Intel® 440BX AGPset: 82443BX Host Bridge/Controller

Specification Update

April 1999

Order Number: **290639-005**

Figure 1: Waveform of Primary Test mode

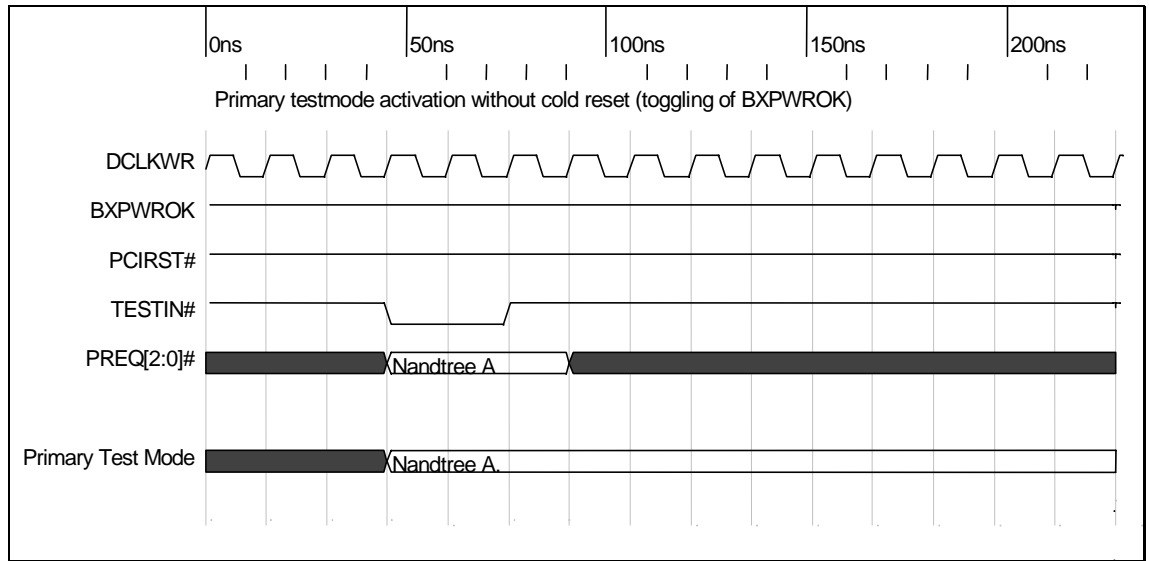
The primary test mode is enabled via TESTIN# pin. To enable a Nand Tree primary test mode, the TESTIN# input pin is asserted low and a 3-bit binary pattern is presented on the PCI PREQ[2:0]# input pins. Table 1 shows the PREQ[2:0]# signal encoding for Nand tree test modes enabled via the TESTIN# pin.

The Figure 1 timing diagram shows the sequence required to enable a primary test mode. Note that the TESTIN# input pin acts as a latch enable, and the PREQ[2:0]# pins act as latch inputs. The test mode is decoded from the output of the latch.

Figure 2: Typical power-up sequence

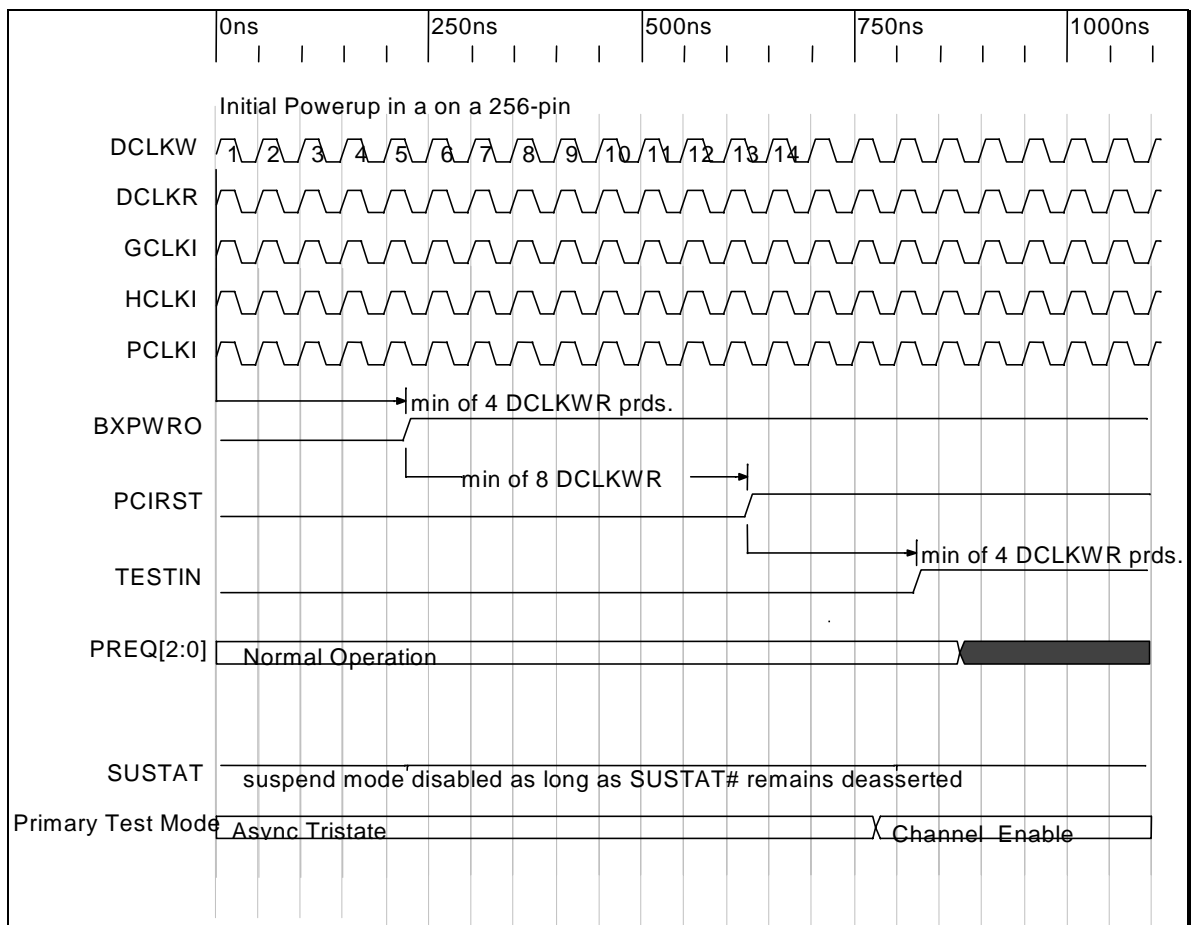
Figure 2 shows the typical power-up sequence of an 82443BX on a 256-pin tester.

At time 0, PCIRST# and TESTIN# must be asserted. The BXPWROK signal must also be asserted to indicate that a cold reset is in progress.

Once PCIRST# is deasserted, on the fourth DCLKWR positive edge, the TESTIN# can also be safely deasserted. PCIRST# and TESTIN# should not deassert at the same time because a race condition prevents the circuit from guaranteeing proper latching of primary test modes.

Figure 3: Nand Chain A0 Connectivity

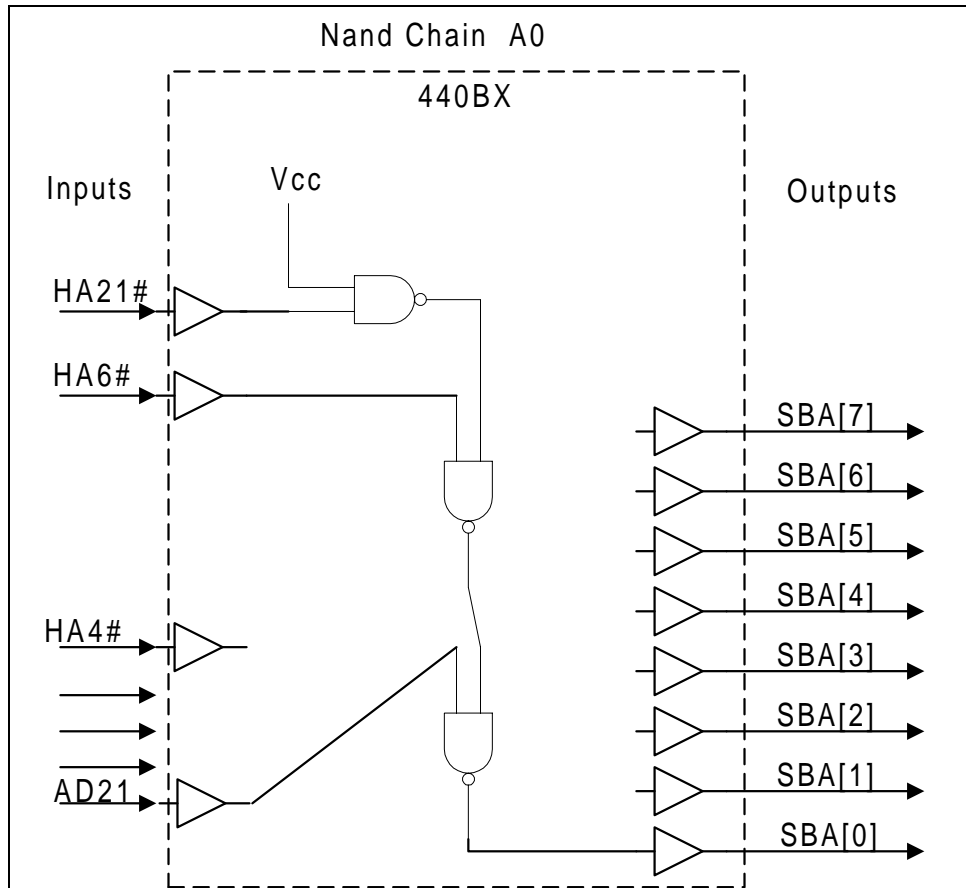
The Nandtree A test mode is used for board level connectivity test. Its main purpose is to detect connectivity shorts between adjacent pins and to check proper bonding between I/O pads and I/O pins.

To help reduce the board level test cost, the Nand chain is limited to 60 pins per chain. This is accomplished by implementing 8 separate Nand chains.

A conceptual diagram of the Nandtree is shown in figure 3.

Figure 4: Waveform of Nand Chain #A7 Test

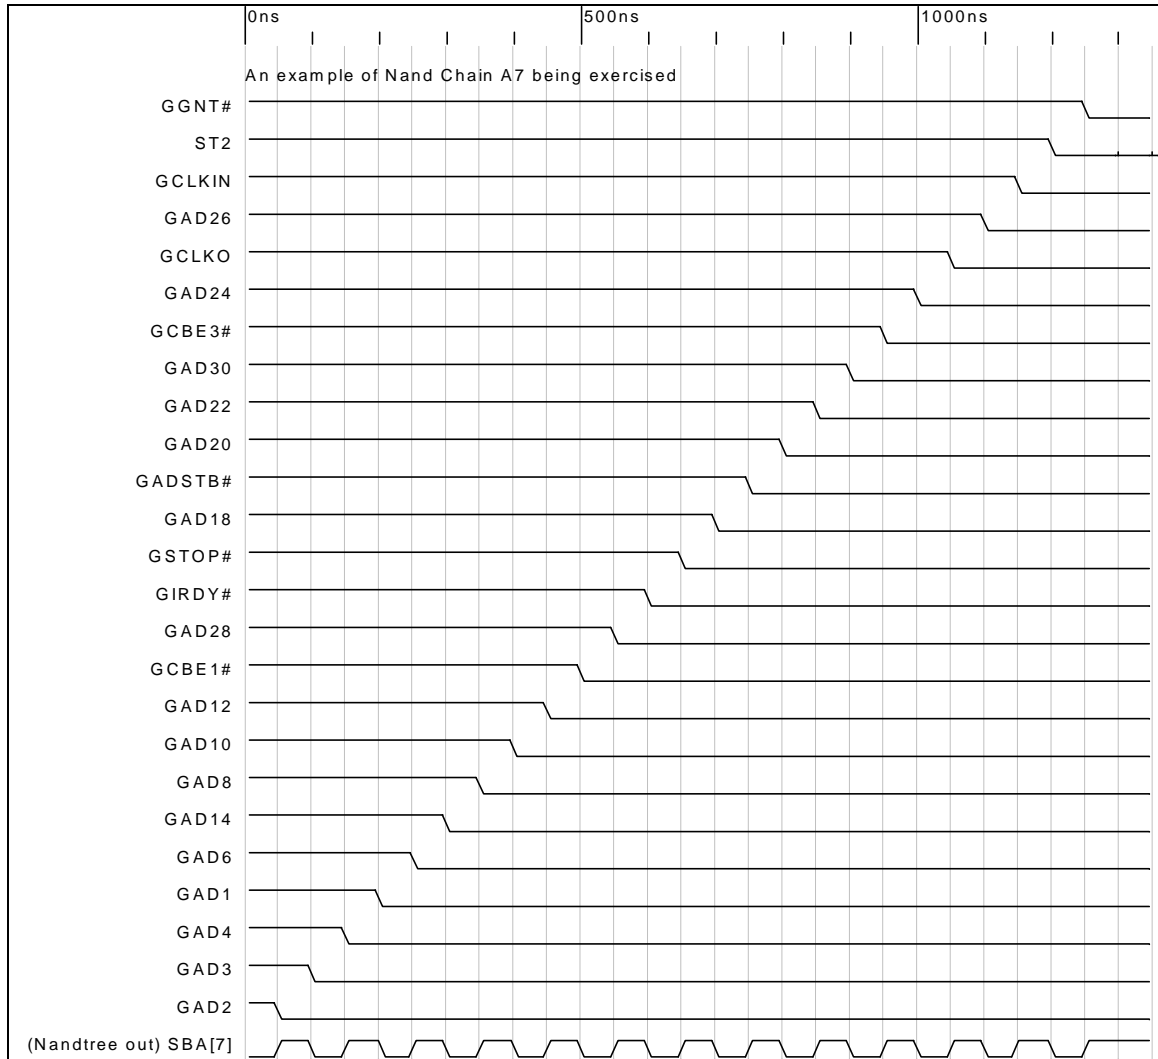
An example Nandtree test is shown in Figure 4. At first, all the input pins are driven to logic 1. Next, each input pin is driven to logic 0, in a sequence, so that the output pin, in this case SBA[0], toggles. By observing the Nandtree output pin, one can detect shorted and unconnected pins.

Figure 5: Waveform of Nandtree Chain Pair up (A4 and A8) & (A5 and A9)

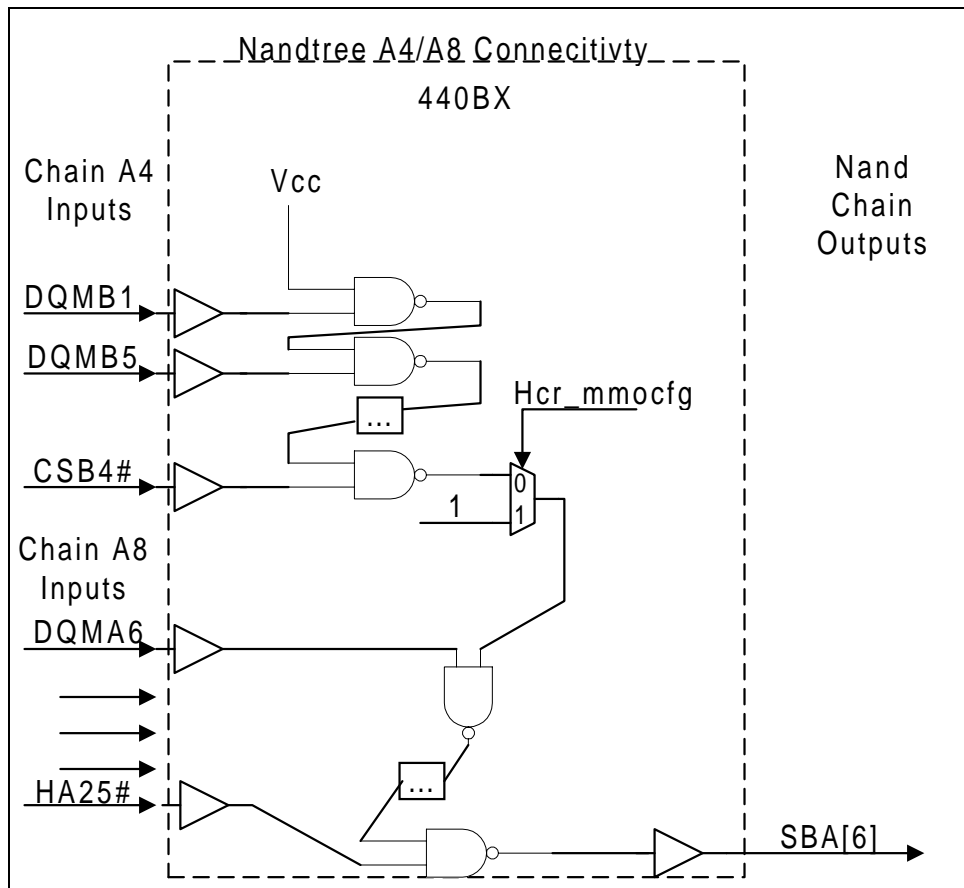
¹ - When MMO mode is disabled, Nandtree chains A4 and A5 are also deactivated. When MMO mode is enabled, Nand chains A4 and A5 are active during Nandtree A test mode. The output of Nandtree chains A4 and A5 (when MMO mode is enabled) must always go through chains A8 and A9, respectively, before it comes out on SBA[4] and SBA[5]. MMO mode is the MAB7# strap configuration controlling the “mobile mode operation”. When MMO mode is enabled the lower order Nand tree chains of the paired groups are also tested.

*NOTE: Chain #A5, DCLKRD: This pad/pin was in use as part of this chain for the B1 stepping of the 82443BX. This pad/pin was removed from the chain for the C1 stepping. This should be the only chain that fails on the 82443BX C1 stepping if the 82443BX B1 stepping Nand tree test are used. All pins tested after DCLKRD will give the opposite data when testing an 82443BX C1 step device with the 82443BX B1 step Nand tree test.

To repair the Nand tree test of Chain #A5/#A9 (MMO enabled) for the 82443BX C1 stepping, remove DCLKRD from the test and invert the expected data for all pins (MAA13, MAA7, CKE5, CKE1, MAA12, MAA11, MAA3, MAA10, MAA1, MAA9, MAA8, MAA5, MAA6, MAA4, MAA2, and MAA0) which were tested following the DCLKRD pin.

Figure 6: Diagram of Nandtree B Test mode

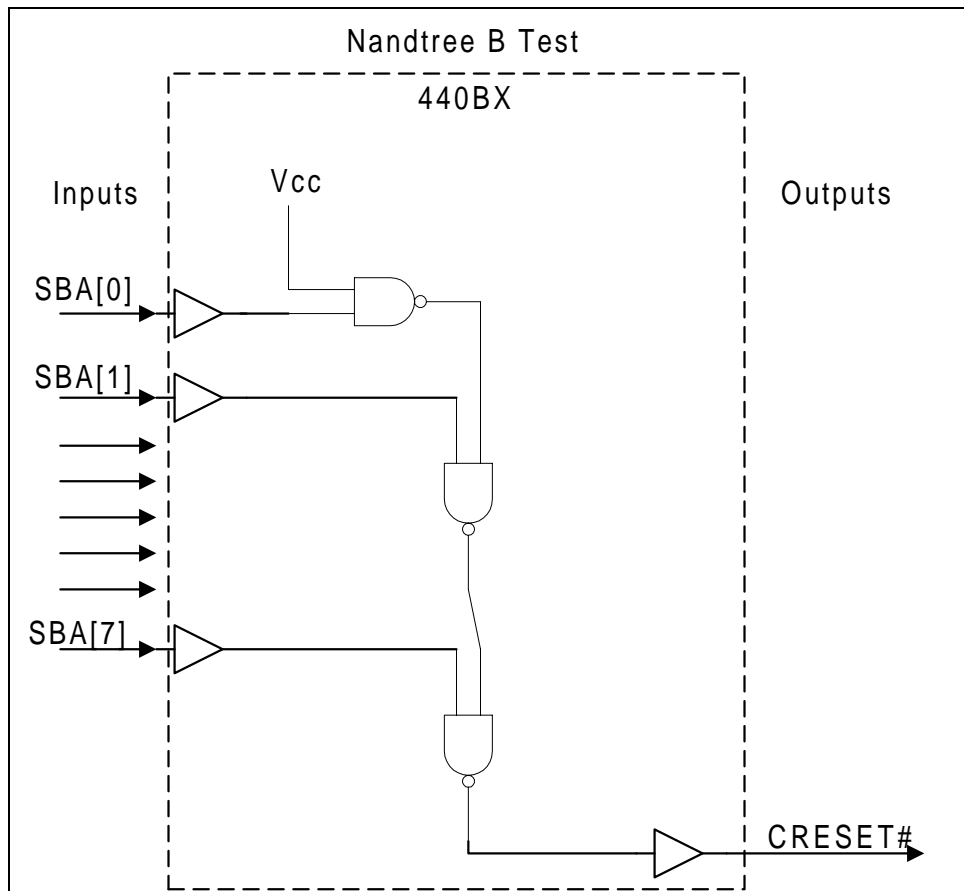
The Nandtree B test mode is used to test the SBA[7:0] pins. These pins are outputs during the Nandtree A test mode and are not tested in that mode. In Nandtree B test mode, the SBA[[7:0] signals become inputs and the CRESET# pin becomes the output.
